MONITORING YEAR 1 ANNUAL REPORT

LONE HICKORY MITIGATION SITE

RE: Lone Hickory Mitigation Site – Monitoring Year 1 Report Final
Yadkin River Basin – CU# 03040101 – Yadkin County
DMS Project ID No. 97135
Contract # 006897

Wildlands Engineering, Inc. (Wildlands) has reviewed the Division of Mitigation Services (DMS) comments from the Draft Monitoring Year (MY) 1 report for the Lone Hickory Mitigation Site. Wildlands' responses to DMS' report comments are noted below in *italics*.

Figure 3.0 Integrated Current Condition Plan View Map (Key)
 Lone Hickory Mitigation Site
 DMS Project No. 97135
 Monitoring Year 1 - 2019

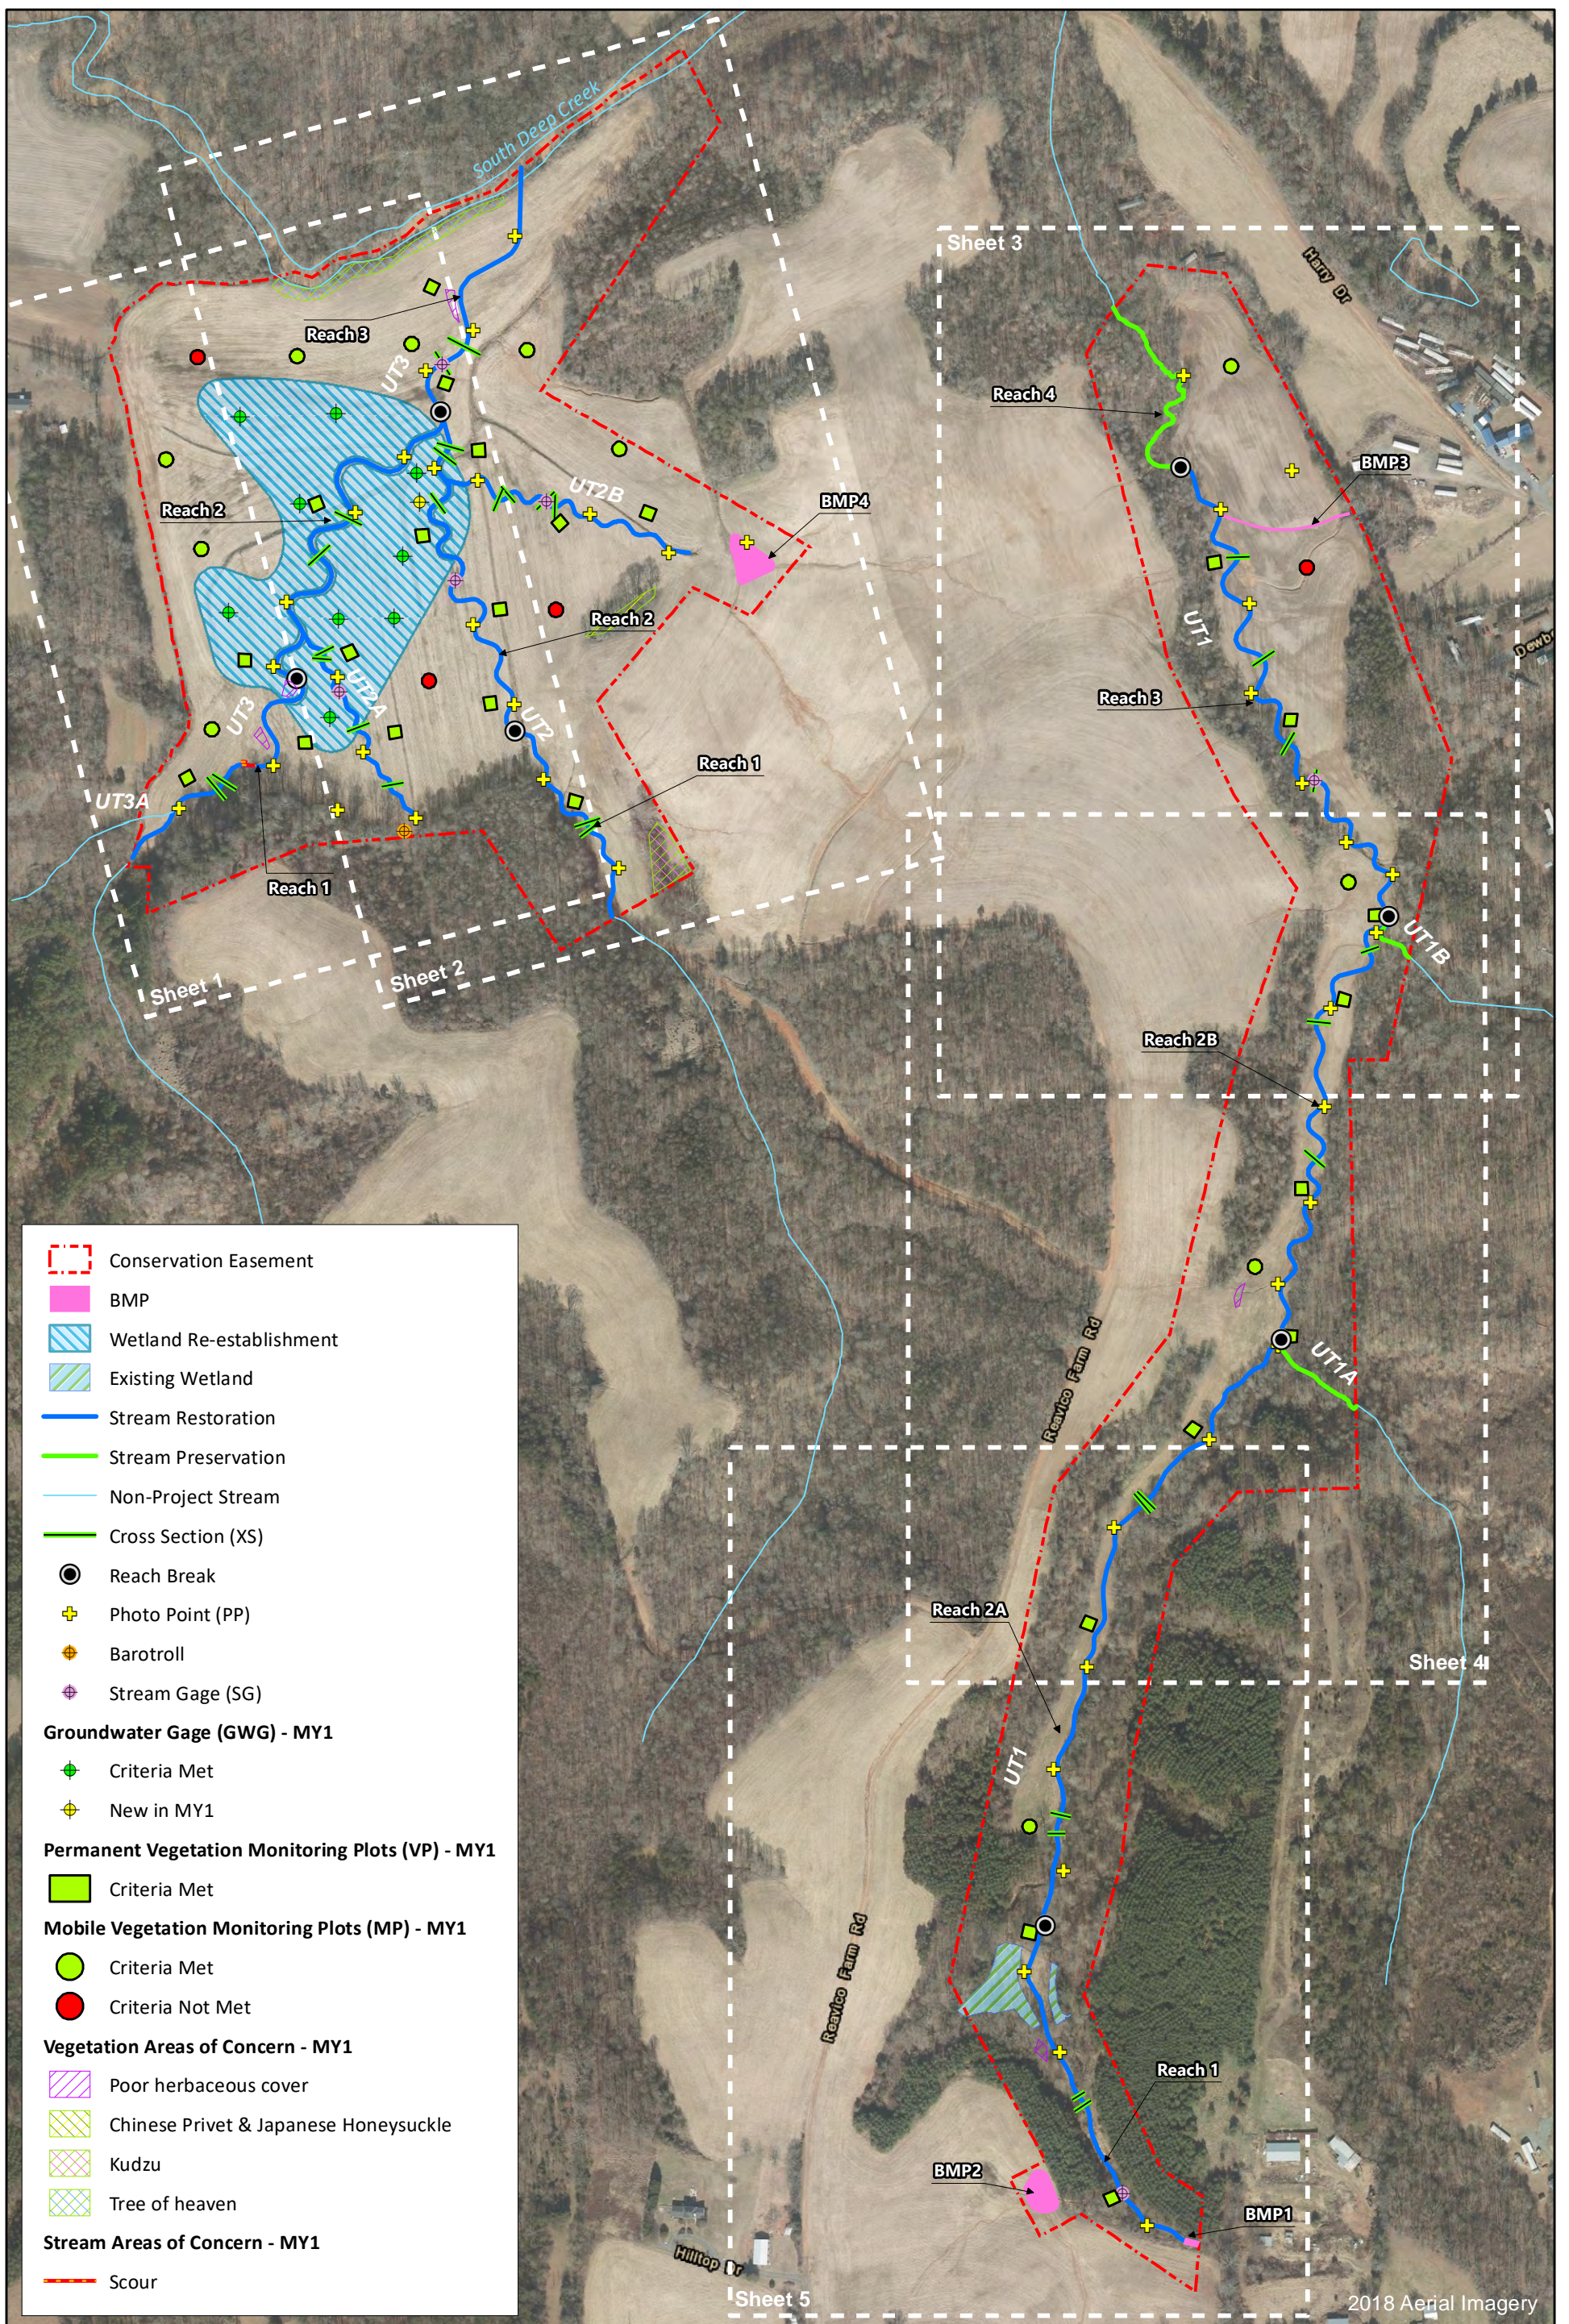
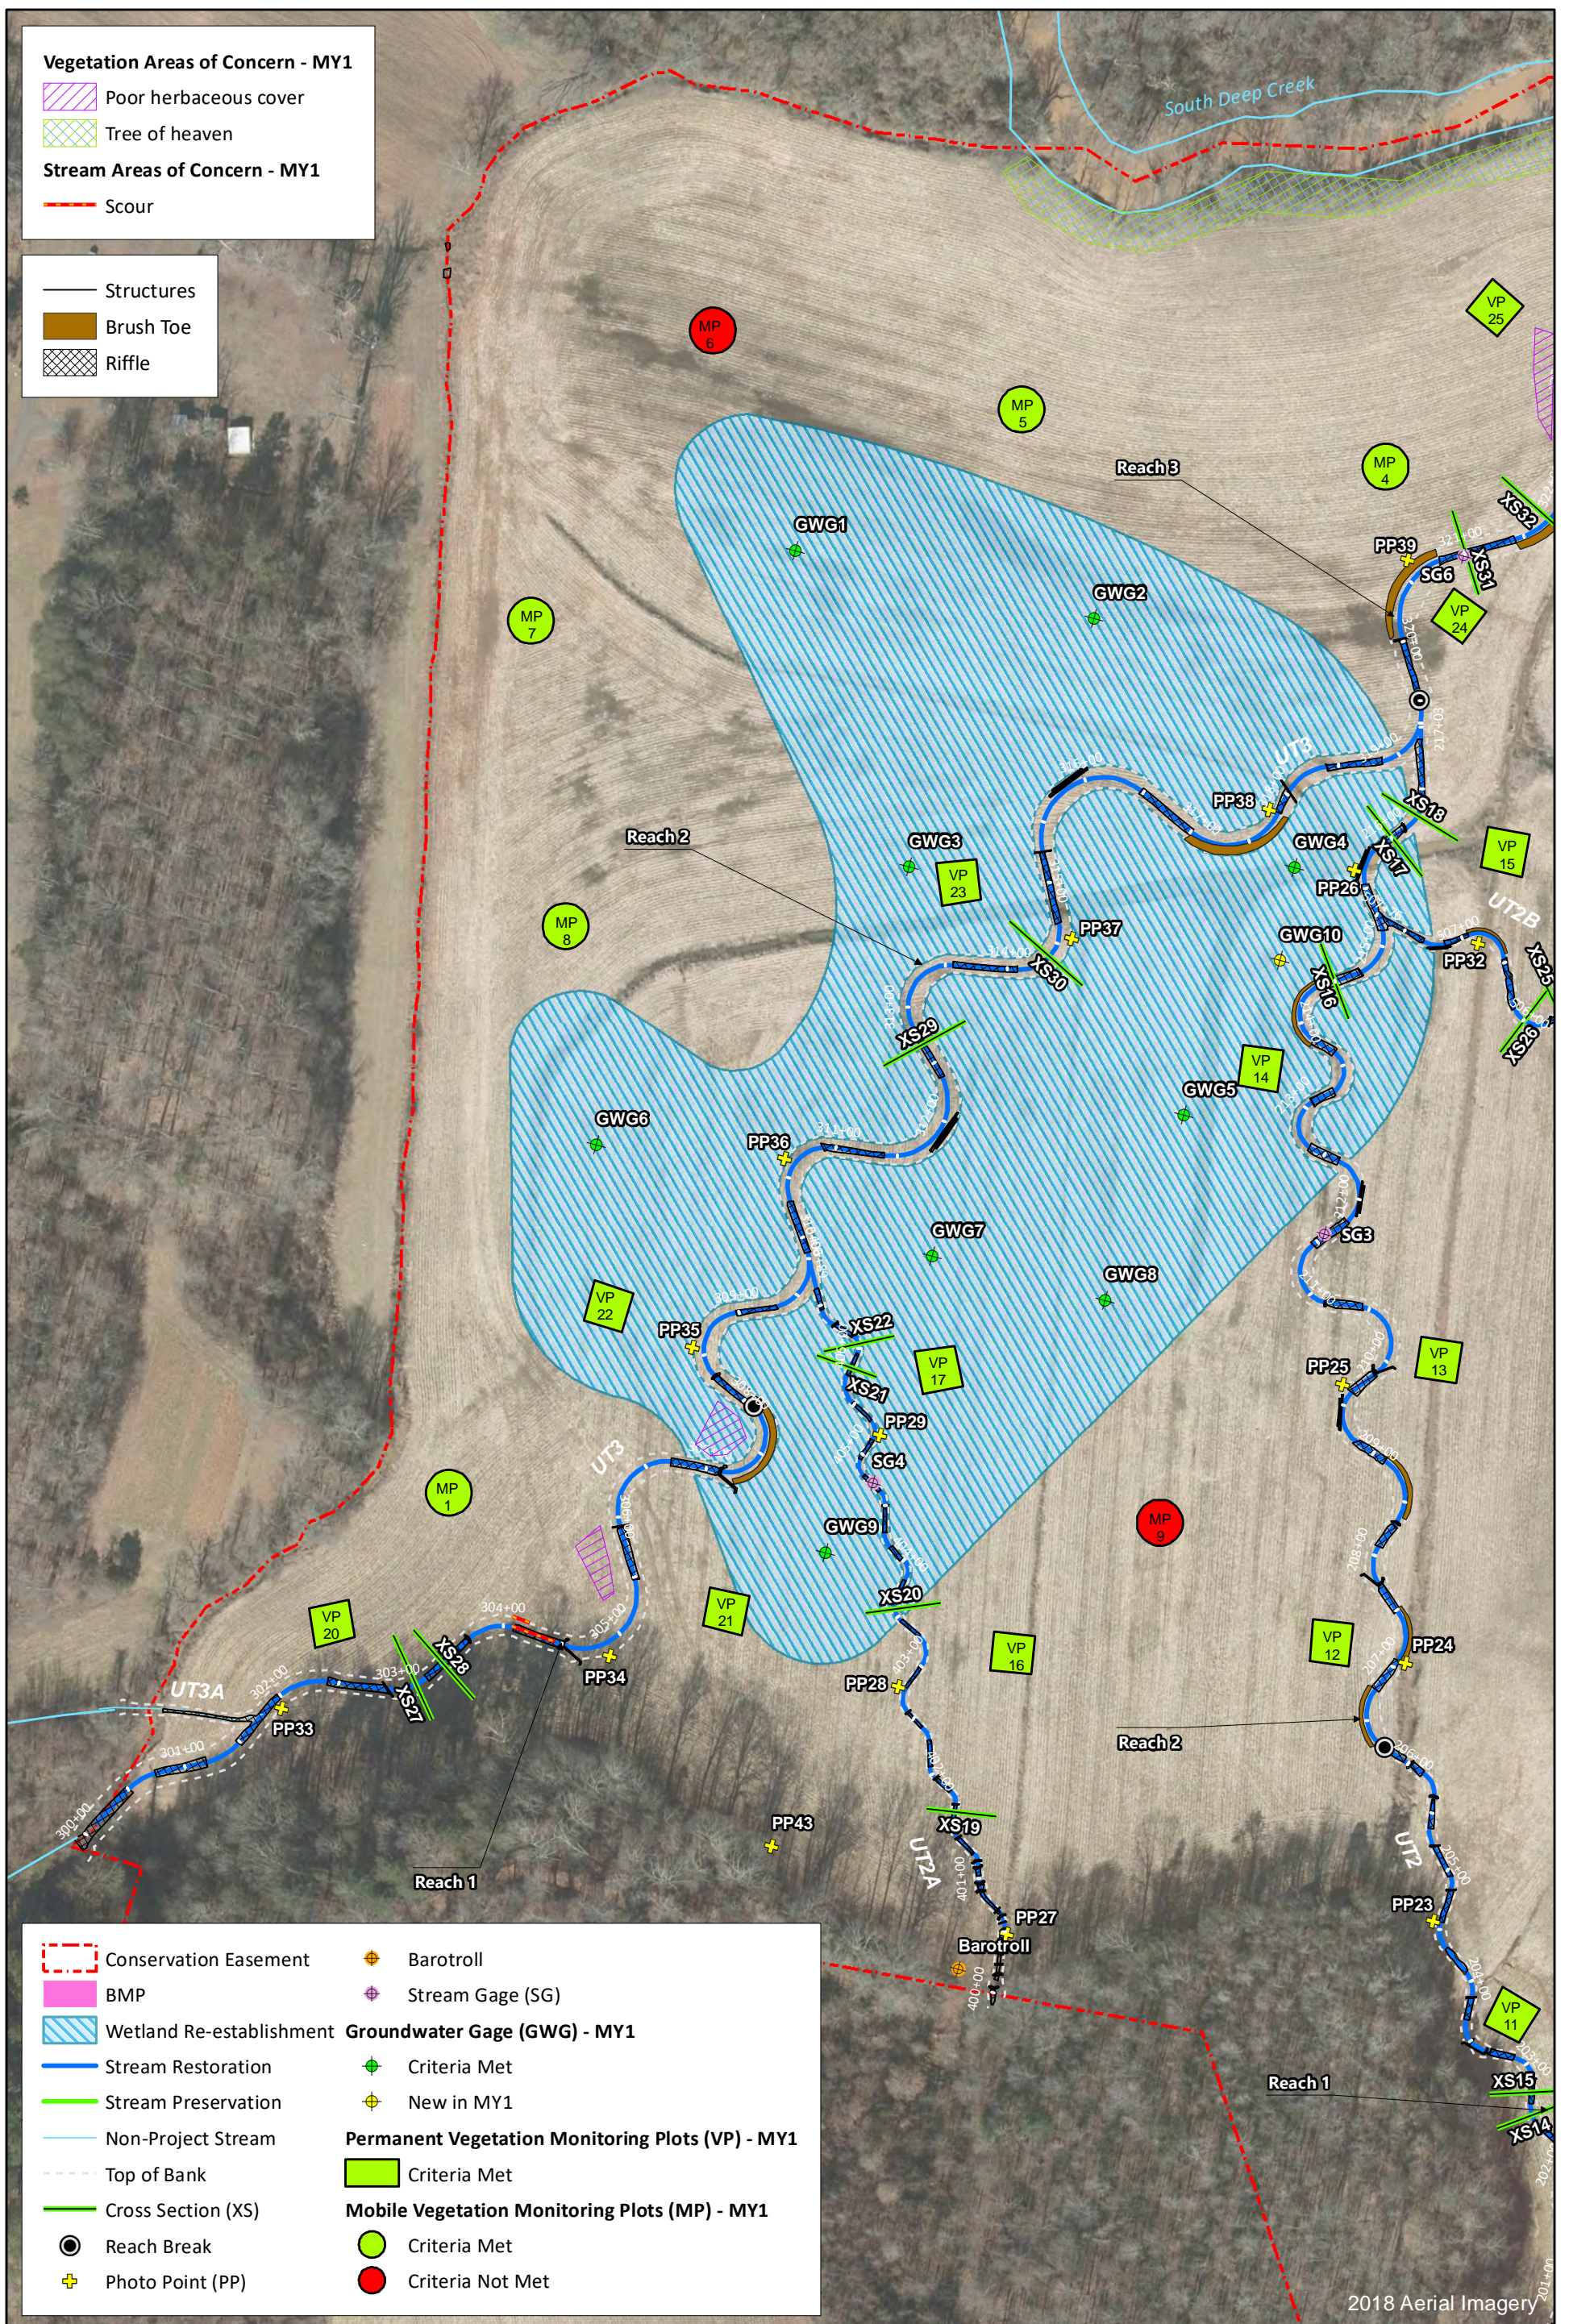
DMS comment; Section 1.2.4 – Stream Hydrology Assessment & CCPV Maps: Do the CCPV maps show the October 2019 relocated stream gages on UT2A and UT2B or the MY0-MY1 gage locations? Since these gages were not relocated until October 2019, DMS recommends showing the previous MY0 locations in the MY1 report and updating the mapped locations (and digital support files) in the 2020 - MY2 report. Please address and update the report text accordingly.

Wildlands response; The CCPV maps submitted with the MY1 draft report showed the relocated stream gage locations on UT2A and UT2B. The CCPV maps and digital support files have been updated to show the previous MY0-MY1 stream gage locations on UT2A and UT2B and text has been added to section 1.2.4. Going forward, the MY2 report will show the relocated stream gage locations.
